Proposal for Corrigendum of Supplement 15 to the 00 Series to Regulation No. 4 (Illumination of Rear Registration Plates) and for Corrigendum of Supplement 18 to the 00 Series to Regulation No. 23 (Reversing and Manoeuvring lamps)

Submitted by the expert from Germany

The present proposal is intended to clarify the provisions regarding the approval marking of Regulations Nos. 4 and 23. The modifications to the existing text are marked in bold for new or strikethrough for deleted characters.

Figure 1

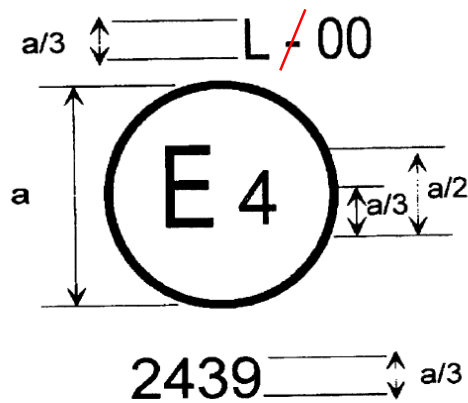
Annex 1, Figure 1, amend to read:

- Annex 1 to Regulation No. 4: The hyphen is an editorial error of the past. It was never required and cannot be found in any approval mark.
- Paragraph 4.7 of Regulation No. 23: At its sixty-sixth session GRE adopted Supplement 18 to Regulation No. 23 concerning the provisions for manoeuvring lamps (ECE/TRANS/WP.29/GRE7/66 para. 21). However, it was not intended to require mingled letters for the approval mark of manoeuvring lamps. It should be borne in mind that mingled marks require special tooling which causes additional costs without any benefit for legibility. It is therefore proposed to

Figure 1

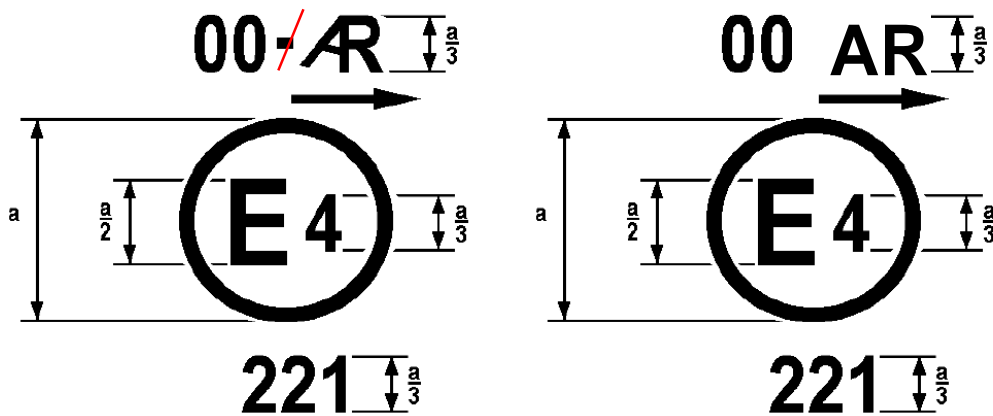
Annex 2, Figure 1, amend to read:

- Annex 2 to Regulation No. 23: The hyphen is an editorial error of the past. It was never required and cannot be found in any approval mark.
